SUBJECT: Forwards EPRI NDE Ctr rept of results of visit to evaluate
 Loop C Feedwater Expander-To-Nozzle Weld, as supplement to
 90-day inservice insp rept, per 921020 request from Project
 Manager.

H. B. ROBINSON STEAM ELECTRICAL PLANT, UNIT NO. 2
DOCKET NO. 50-261/LICENSE NO. DPR-23
SUPPLEMENT TO 90-DAY INSERVICE INSPECTION REPORT

SUBJECT: Subscriber Requested Assistance Provided at H. B. Robinson

CP&L
 Caroline Power & Light Company
NDE DRAWING ATTACHMENT

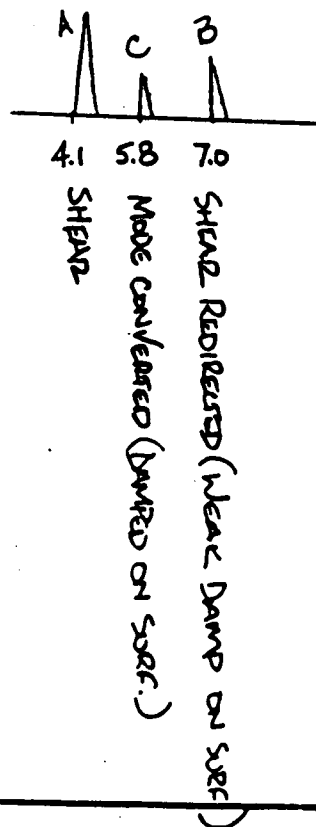
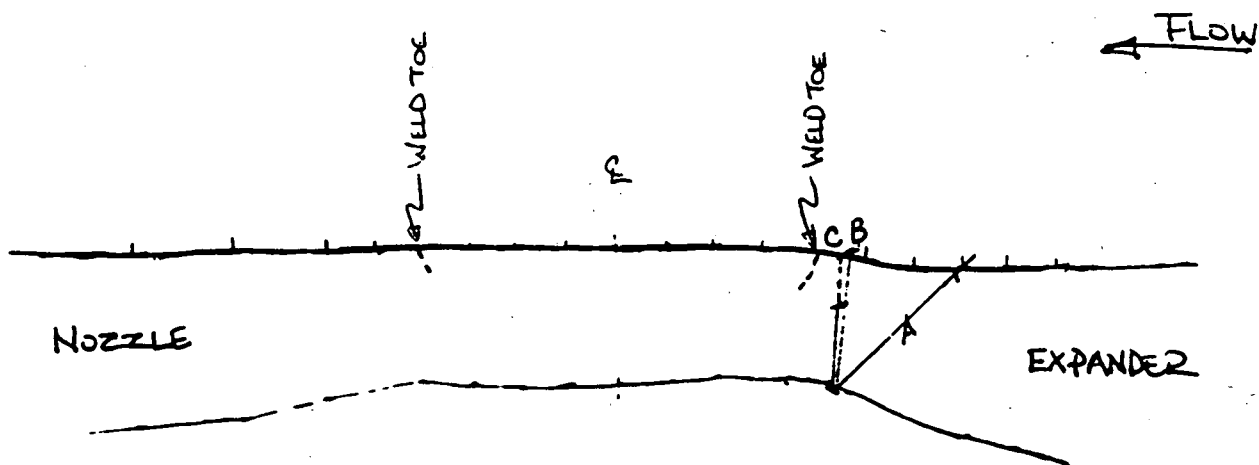
reflecting perpendicular to the outside surface. The only means of explaining the occurrence of all three signals simultaneously is that a counterbore must exist at this location. A sketch made by Ed Black showing the associated beam paths is attached.

Based on the examinations performed by CP&L, the portion of the Loop C feedwater expander-to-nozzle weld examined does not contain crack indications, rather counterbore signals were obtained and confirmed. If other feedwater welds in the plant contain indications which are still not fully resolved, high angle longitudinal waves should be utilized to confirm that cracking is not present.
